AGENDA
Glen Ellyn Architectural Appearance Commission
Wednesday, November 9, 7:00 p.m.
Glen Ellyn Civic Center
Galligan Board Room
535 Duane Street

DRAFT MINUTES
ARCHITECTURAL APPEARANCE COMMISSION MEETING
October 12, 2022

FROM: Atrian Fard, Senior Planner
Brad Iwicki, Planning Intern

CLIENT: PROJECT NAME / ADDRESS / SHEET TITLE	
BRICK & MORTAR - GLEN ELLYN COWORKING OFFICE SPACES 411 MAIN ST., GLEN ELLYN, IL 60137	
GENERAL NOTES	
DATE	10/18/2022
PROJECT NUMBER	21898
SHEET NUMBER	G1

WEST ELEVATION
1/4" = 1' - 0"

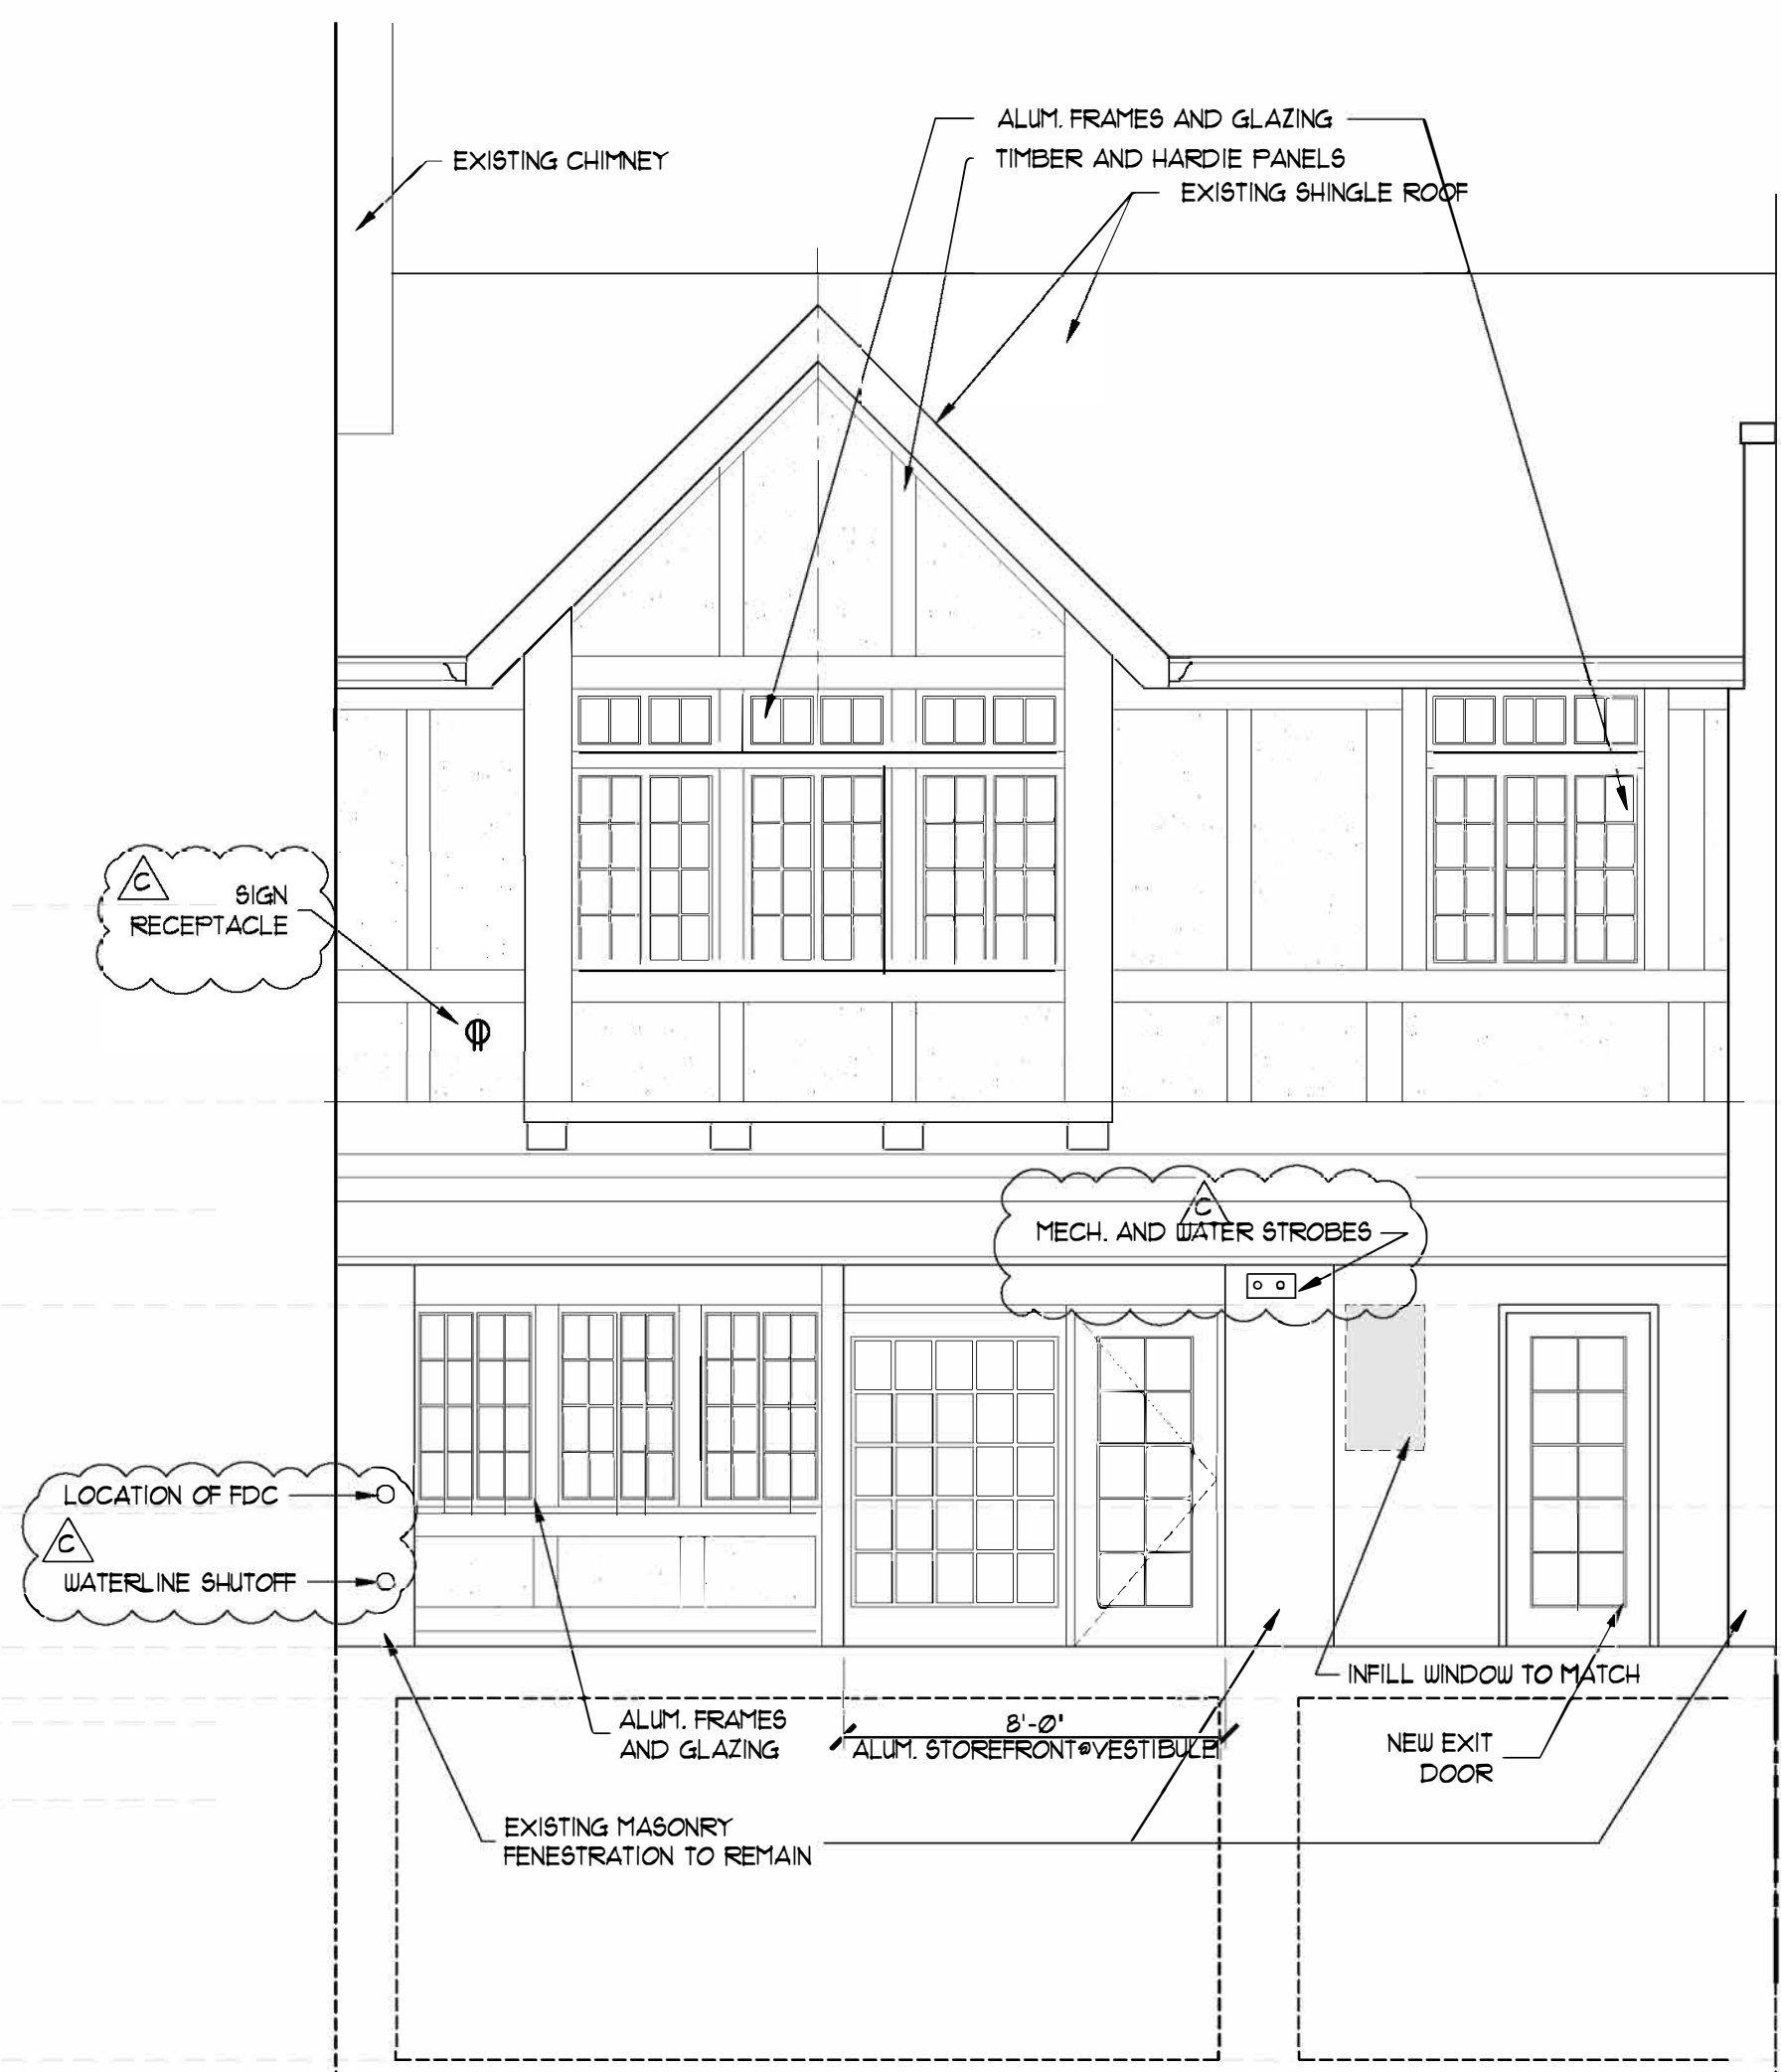
the proposed is unacceptable and he wouldn't recommend it for approval. He added that the entry door in its current configuration is "lost in translation," suggesting that the floor plan could be designed to accommodate it. Referencing Brick and Mortar's branding, Commissioner Mees suggested that the Petitioner might find a way to work its white-and-black motif into the façade while preserving building details (and perhaps garnering award recognition). To illustrate this idea, she presented renderings, including one depicting the "Liberty of London" building featuring the store's name atop iconic Tudor Style expression. She remarked that a center entrance is more appropriate. While voicing agreement with the previous comments, Commissioner Rahn, said he didn't have as large an issue with the modern approach to the street level, but would like to see a closer relationship with the original upper floor. He pronounced the elimination of brick a "missed opportunity" to link to the community's heritage.

The Commission motioned to defer making a recommendation in order for the petitioner to propose a revised concept. The AAC requested to see interior first floor plan for the meeting on November 9th, 2022.

The petitioner submitted new renderings proposing the remodel of the building's west (front), south, and east elevations. The revisions show the exterior design, materials, color, and interior floor plan. More information about the project is below:

West Elevation: The existing façade is brick, stone, and timber with masonry fenestration. The petitioner proposes to replace the ground

floor façade with Lorraine White brick veneer (Glen-Gray Lorraine White Handmade). The petitioner proposes two design options for the second-floor front façade: Option 1 features Hardie planks in light gray (BM Gray Owl) paired with darker gray (BM Horizon Gray) board and batten, and Option 2 represents dark (BM Onyx) boards with Horizon Gray Hardie planks. Both options will include Onyx trims with dark bronze aluminum windows.

UPPER FLOOR
1/4"=1'-0"

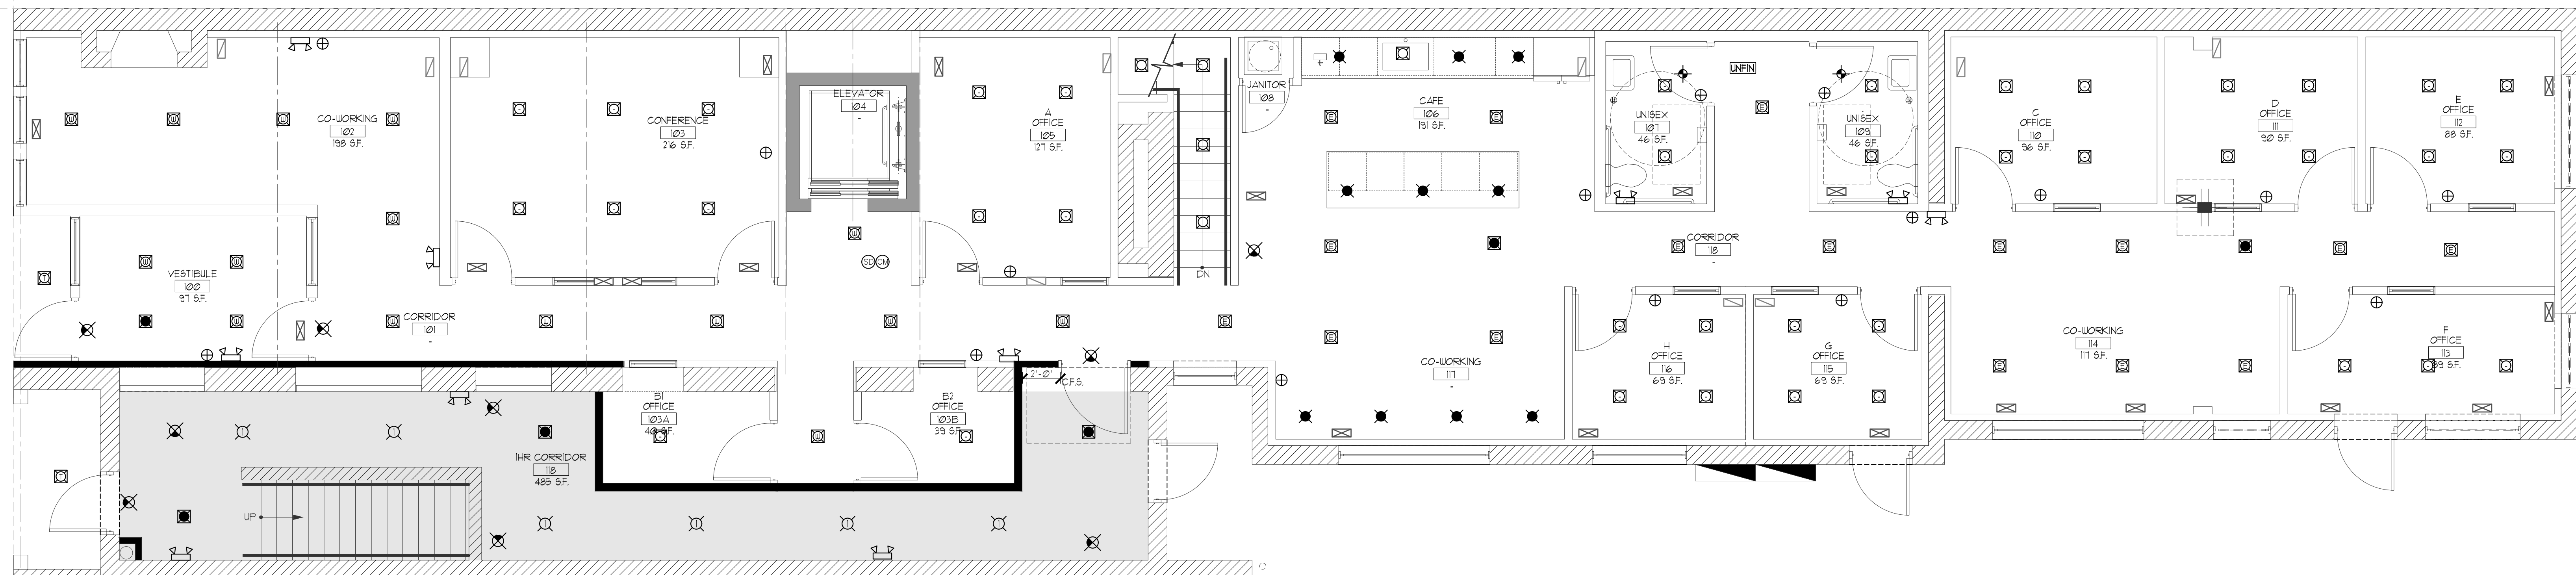
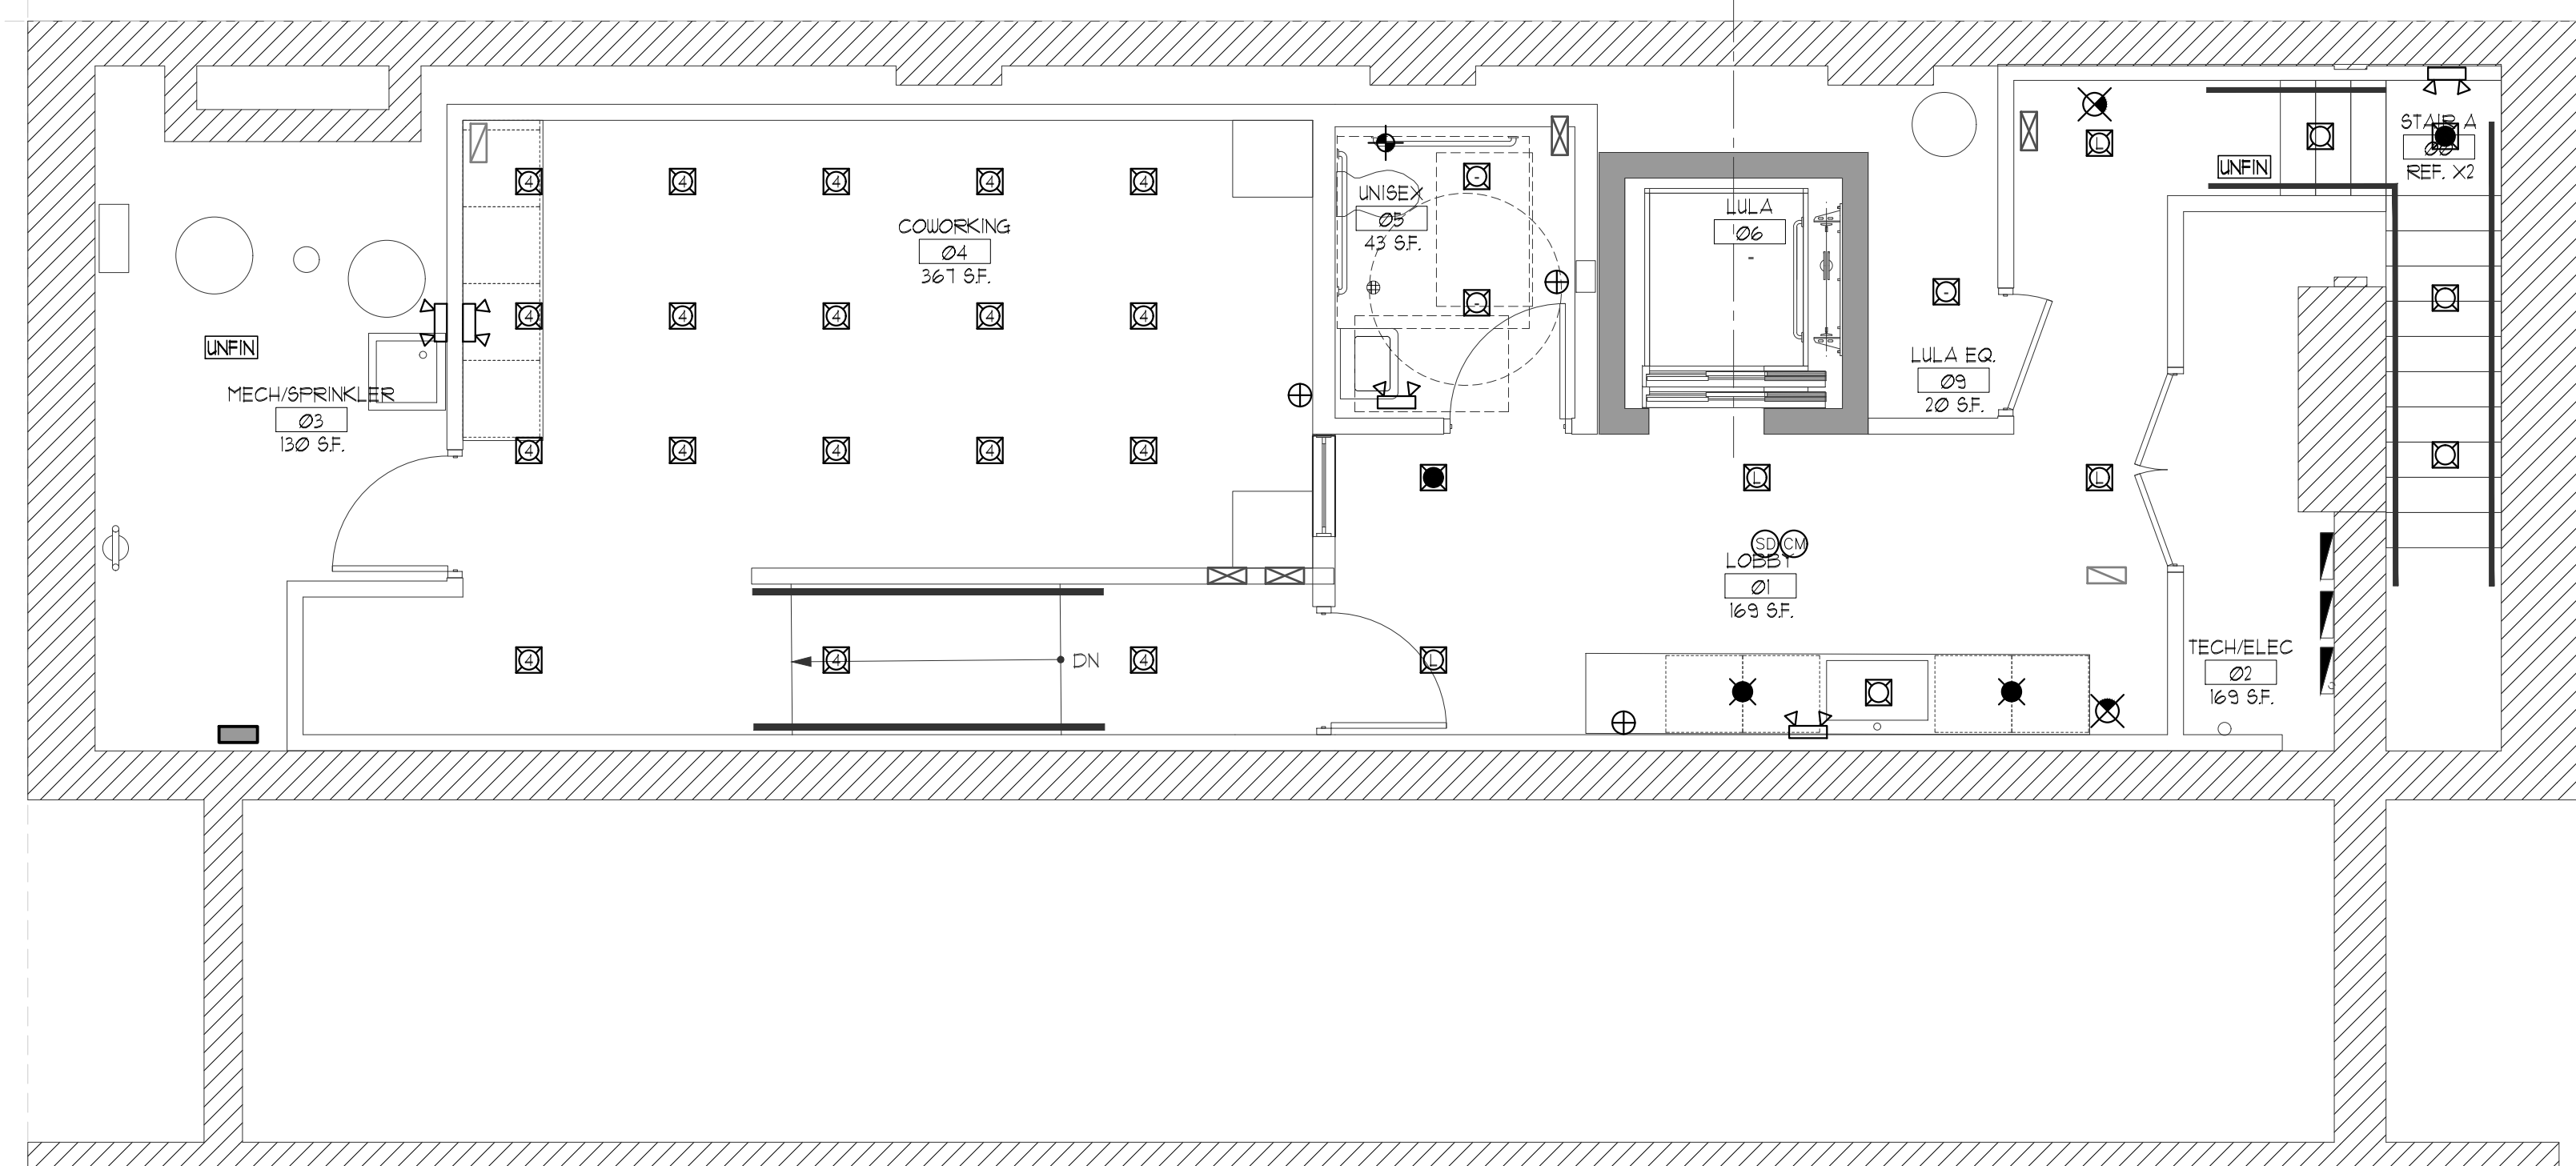
Commissioner Goronov said he wants to see a floor plan for 411 N. Main, which he called "a jewel," adding that it would be easy to make the building "true to itself and be fresh." Ms. Fard said she can add this to requirement for everyone, though it's not under AAC purview to request changes to it.

Interior Renovation: The interior of the building will be renovated as part of the project to prepare the space for the new co-working office. The new proposal shows the mail boxes on one side of the storefront vestibule. The petitioner stated that the symmetry of the entryway cannot be maintained and provided the building's first floor plan at the Commission's request. A building permit has been applied for by the petitioner.

FRONT ELEVATION

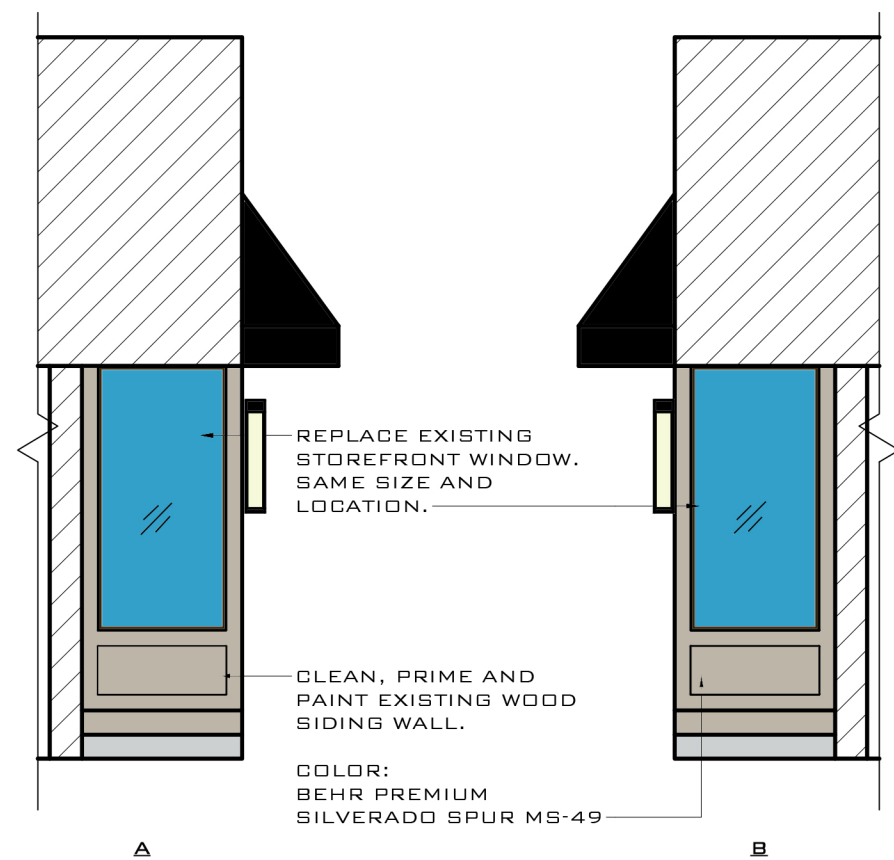
Expressing the goal of improving the building and the downtown, the Petitioner indicated she is flexible, and that she could provide renderings. Commissioner Smith said that, after viewing an online illustration of the type of limestone-type material described by the Petitioner, she preferred to keep the existing brick rather than replace it with "cultured stone," which, she said, does not fit in with the context. She further said she likes the awning windows, but is concerned about the palette, and said the light fixtures specified are too contemporary for a "very charming" brick building. Ms. Xim'enez conveyed that she has "no problem" keeping the brick. Commissioner Smith asked the Petitioner's construction contractor (Chris) his thoughts about limestone on the west façade. He said he thinks limestone is too prone to winter damage from snowplowing and salt. Ms. Xim'enez declared, "I think we're keeping the brick." Citing the lack of a rendering as an obstacle to making a decision, Chairperson Jacobson expressed a preference for keeping the brick, a dislike for the mural idea, and the view the AAC is "a little bit on the fence" about the stone vs. brick. She said it's difficult to visualize the front without the awning and how the signage would fit. Renderings with and without the awning and a depiction of the limestone were requested. The discussion was tabled.
